Re: Saratoga Property Owner, LLC – 35 Saratoga Boulevard Proposed Industrial Building  
 Parcel ID#: 021.0-0013-1600.0  
 IBI Project No. **122047**

IBI Placemaking has reviewed the second submittal for 35 Saratoga Boulevard Level 2 Unified Permit Application and 35 SARATOGA BOULEVAD - SITE DEVELOPMENT PLANS.

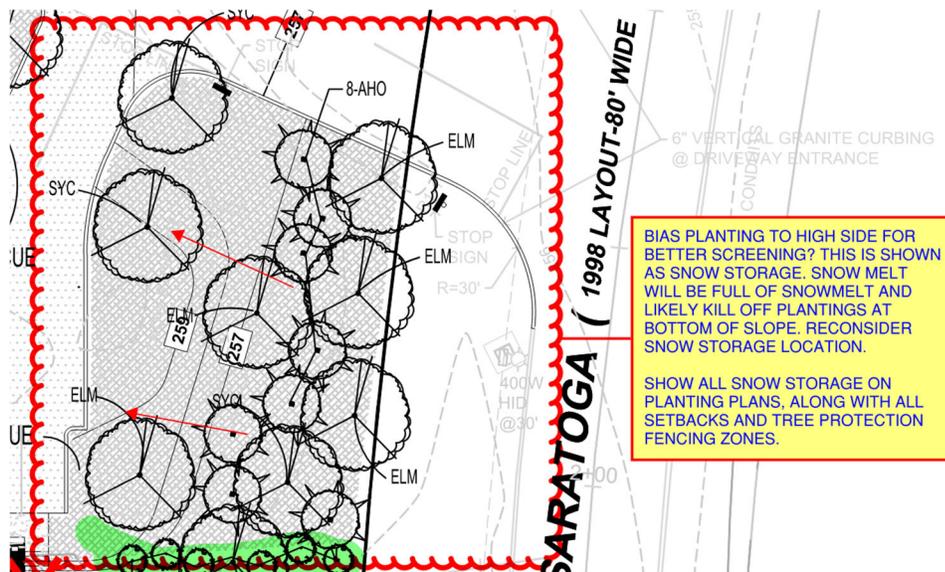
5. SHEET L.1 – LANDSCAPE PLAN - Pedestrians cannot effectively negotiate walkways adjacent to 90-degree, head-in parking without providing wheel stops to prevent overhanging vehicles. If snow removal is an issue with wheel stops, provide wider walkways to ensure pedestrians can pass by an overhanging vehicle. 6 feet is generally the minimum acceptable walkway width for this condition. Typical comment for all locations.
6. SHEET L.1 – LANDSCAPE PLAN – Consider combining the entries off of Barnum Road to reduce the amount of blasting required through the highest point on the site, with a mature forest canopy within the OPEN SPACE AND RECREATION ZONING DISTRICT and eliminate the redundant fire access drive.
7. SHEET L.1 – LANDSCAPE PLAN – Consider reducing the amount of true lawn:

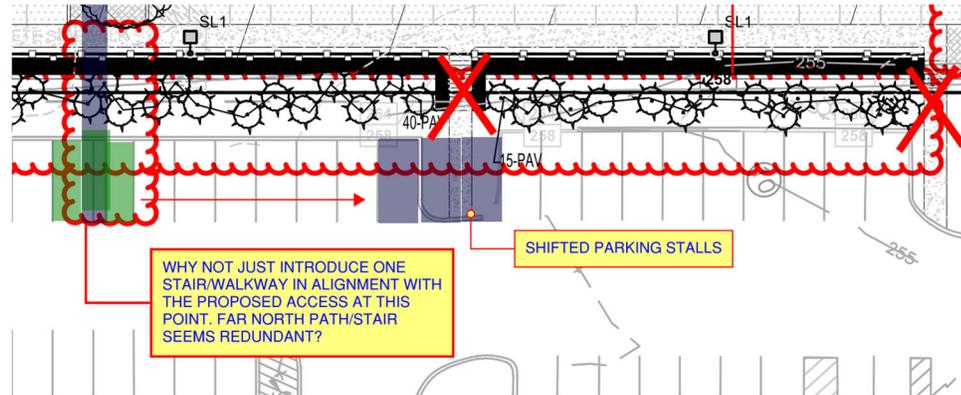
8. SHEET L.1 – LANDSCAPE PLAN – Consider revising the screen planting at the entry off of Saratoga Boulevard:
